BOARD OF WATER SUPPLY

Subject: Final Environmental Assessment for Waimalu Wells I Rock Fall Mitigation
and Drainage Improvements, Aiea, Oahu, Hawaii,
TMK: 9-8-26:72, 9-8-45:36 & 37 and Various Plats and Parcels

The Honolulu Board of Water Supply (BWS) submits the Final Environmental Assessment and Finding of No Significant Impact (FEA-FONSI) for the Waimalu Wells I Rockfall Mitigation and Drainage Improvements situated at TMK 9-8-26:72, 9-8-45:36 & 37 and Various Plats and Parcels, in the Ewa District on the Island of Oahu for publication in the next available edition of the Environmental Notice.

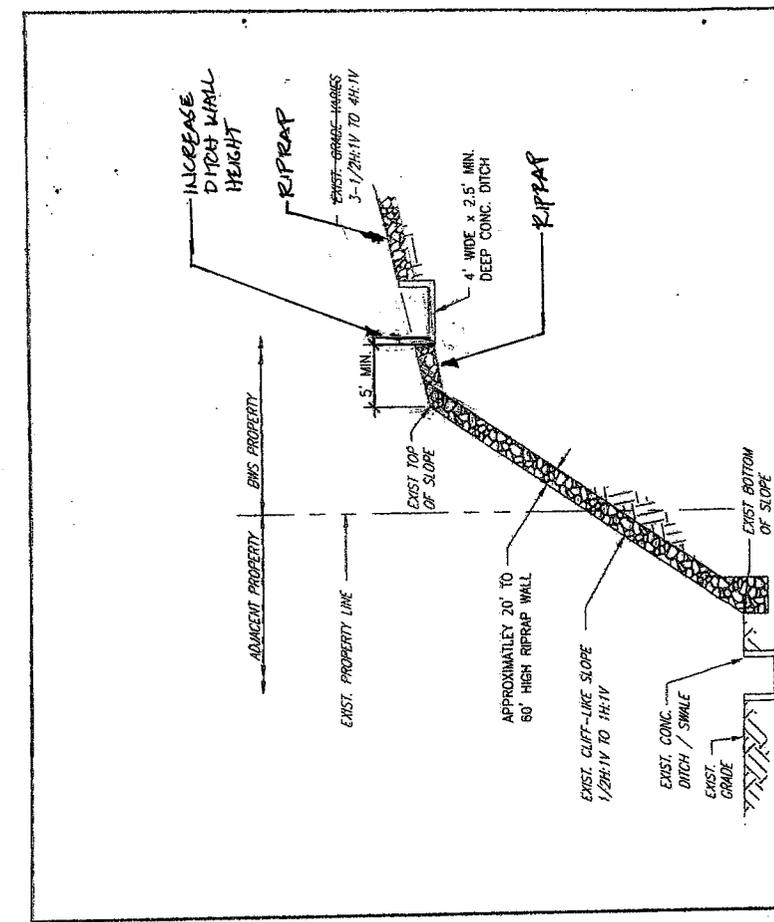
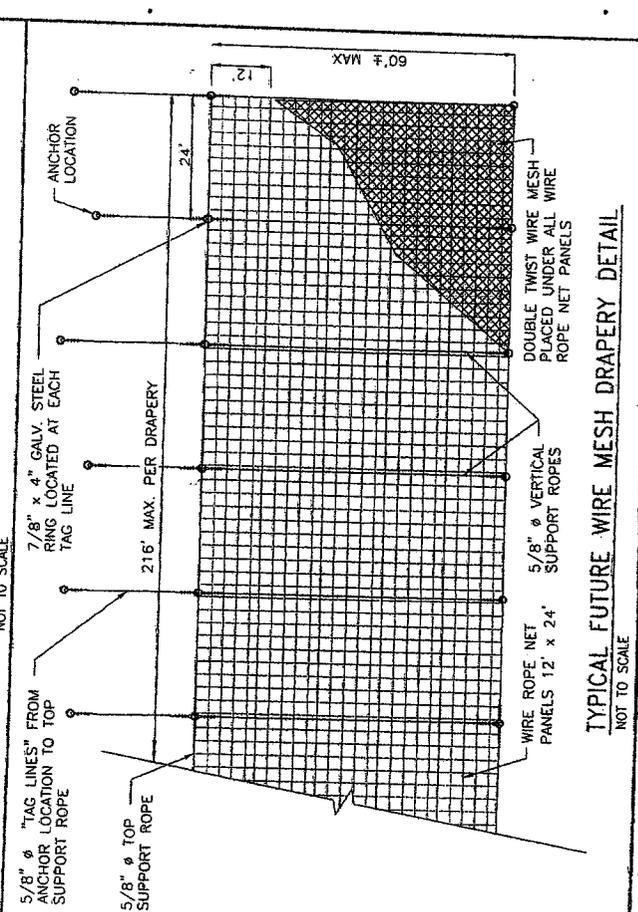
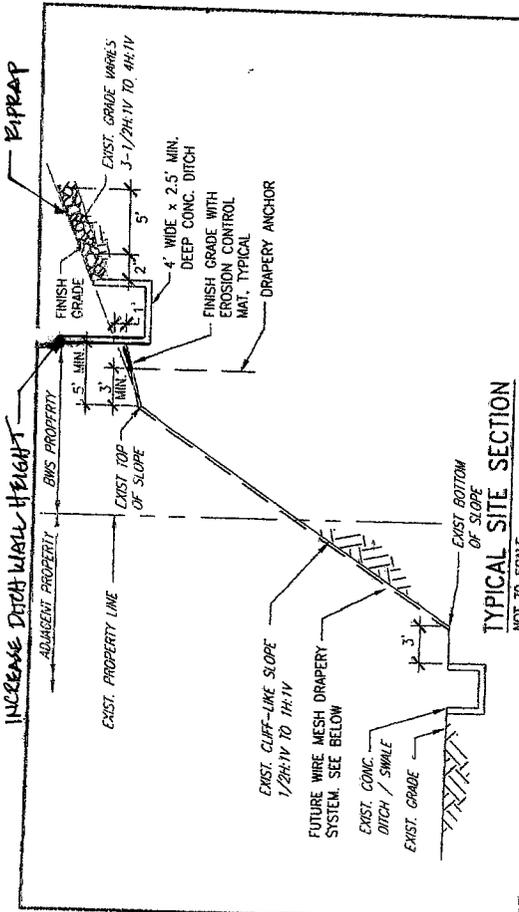
5. One possible solution to comments 2, 3 & 4 above would be to add rip rap on one or both sides of the ditch and make the ditch wall (on the lower side of the hill) higher. This will increase the volume of the ditch before it overflows and will

offer a secondary path for the water flow should the ditch get clogged. The rip rap on the sides of the ditch will minimize vegetation from entering the ditch and will control erosion between the ditch and the top of the slope. If rip rap will be a problem for the preferred alternative, the erosion control mat should be placed up to the edge of the concrete ditch. See the attached sketches.
